## Request for Class II Permissive Change(C2PC)

FCC ID: VG8EC028AYY

This is a C2PC application for which the previous grant was issued on 2023-05-16.

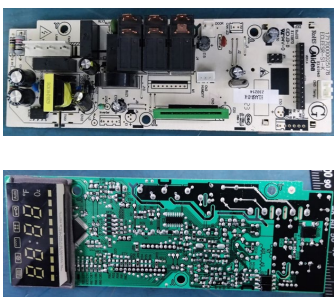
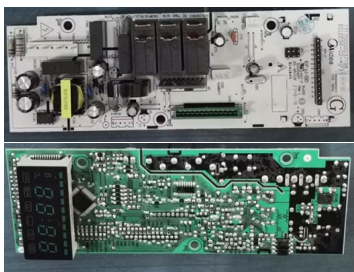
| No.: | Original  | New  | Difference(s)  |
|------|---|--|--|
| 1    |   |    | Keypad:<br>Updated front keypad to accommodate child lock function (Child resistant oven door function).   |
